RE: Proposed Revisions to the Acceptance Criteria for Mechanical Splice Systems  
for Steel Reinforcing Bars AC133-1020-R1

Subject: Proposed Revisions to the Acceptance Criteria for Mechanical Splice Systems for Steel Reinforcing Bars AC133-1020-R1 (MC/VC)

## Comments on AC133-1020-R1

**From:** Paulson, Conrad <CPaulson@wje.com>  
**Sent:** Thursday, September 10, 2020 4:18 PM  
**To:** es  
**Subject:** Comments on Proposed Revisions to Acceptance Criteria for Mechanical Splice Systems  
AC133-1020-R1 (MC/VC)

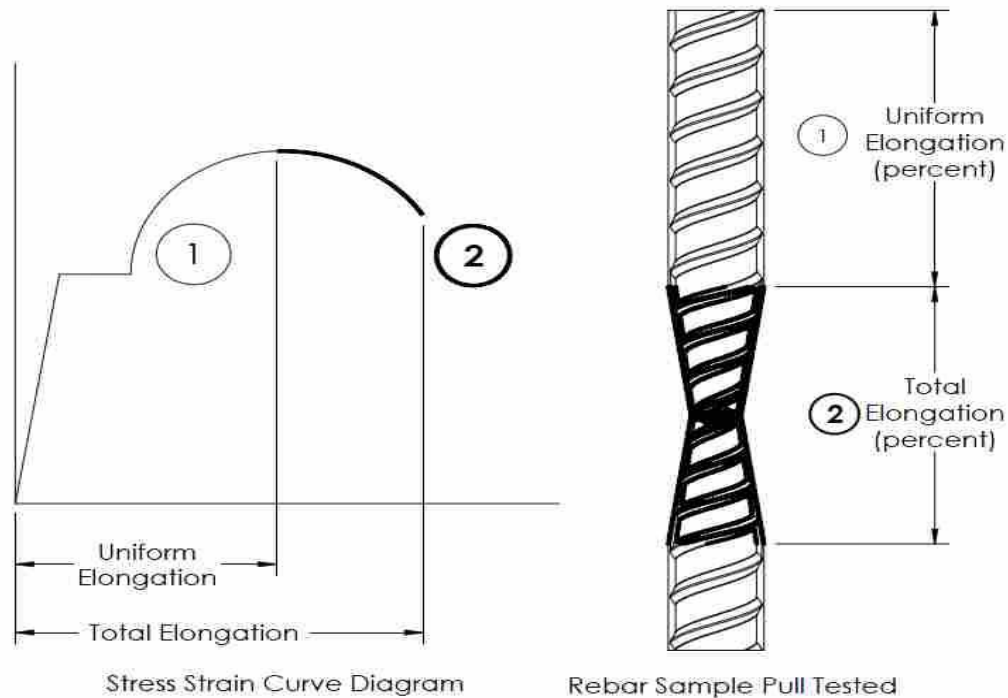
- B) As the rebar is cycled beyond the proportional limit, the reinforcing bar becomes strain hardened.

ACI 439.6R-19 in section 10.3 states “*Inelastic cyclic testing is therefore not recommended for use in evaluation of strain capacity of mechanically spliced A1035/A1035 M (CS) Grade 100 (690) bars. Only test samples cut from original straight lengths of reinforcing steel, not from coil or post-fabricated steel, should be used for tensile strain evaluation.*”

As noted in 439.6R-19 the reinforcing bar Uniform Elongation as defined by ACI 318-19 can be altered in an inelastic cyclic test, such as AC133 testing.

Again, allowing a monotonic tension test could improve this issue. But, Type 2HS mechanical splice under the proposed AC133 does not allow monotonic tension testing.

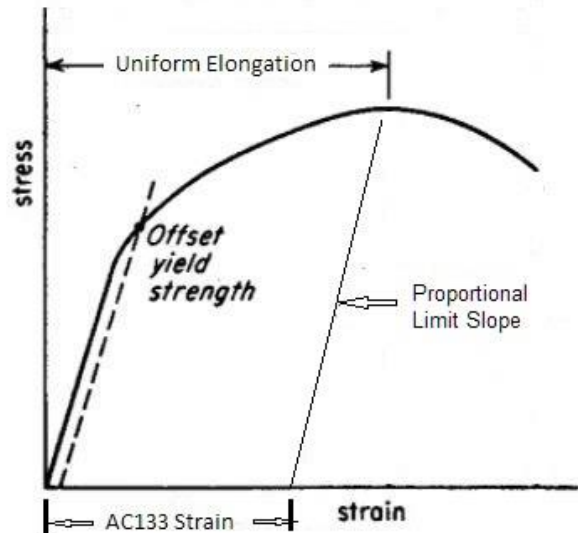
Table 7 should state that it is for ASTM A706 reinforcing bar only.

As demonstrated above in point 4, both ASTM A615 and A706 are silent on how to measure Uniform Elongation and do not require reporting of Uniform Elongation. The proposed AC133 addresses this concern by adding ANNEX B. ANNEX B measures reinforcing bar Permanent Deformation, not Uniform Elongation. Uniform Elongation includes the elongation while under load. ANNEX B allows the reinforcing bar to relax, thus all the strain that would occur under the proportional limit is not included in the ANNEX B measurement. By allowing the strain to be measured post load, as proposed by AC133, some mechanical splicing systems will fail this new requirement while passing per ACI 318-19. This is explained in the diagram below:

AC133 should add the strain that would occur under the proportional limit.

$$\text{Added strain} = \text{stress} / \text{modulus of elasticity} \quad (\text{Added strain} = \text{stress} / 29,000,000 \text{ psi})$$

As an example, if the test sample went to a stress of 90,000 psi the added strain will be calculated as follows:  $90,000 / 29,000,000 = .0031$  strain

**Figure a. Expected stress-strain relationships for spliced and unspliced No.10 (32-mm) ASTM A706 reinforcing steel bars (Dahal and Tazarv, 2020)**

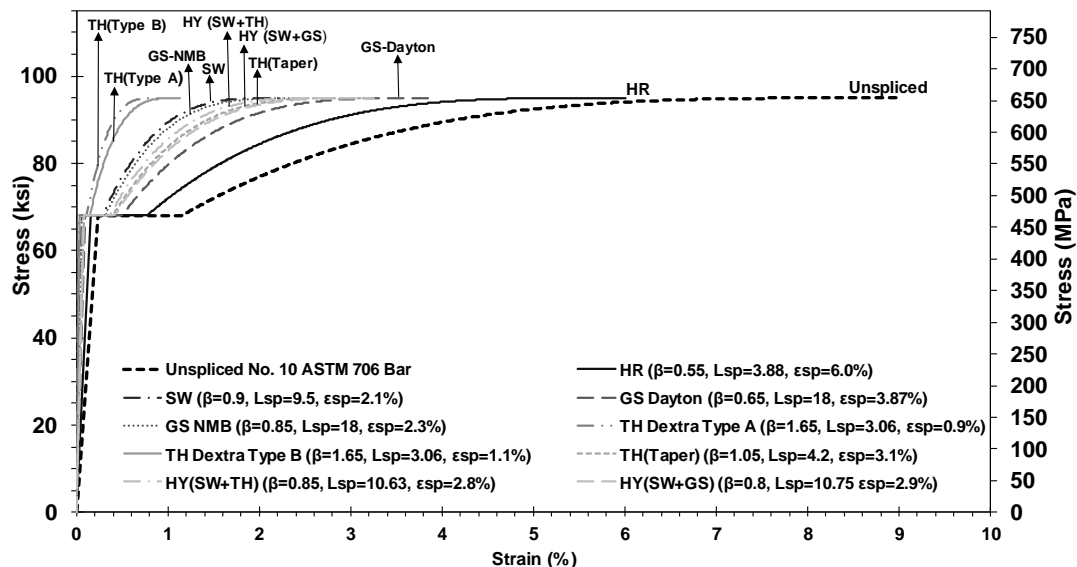
1. ASTM A706 and A615 have different strain limits, which should be included in the table.
2. **Table 7** is presenting the minimum strain requirements for unspliced bars not spliced bars. It has been well documented (e.g. more than 160 coupler tests by Dahal and Tazarv, 2020) that couplers reduce the strain capacity of a splice compared with unspliced specimen from 30% to 90%. For each bar size, coupler type, and manufacturer, the strain limit will be different. The limits in **Table 7** cannot be met for mechanical splices.
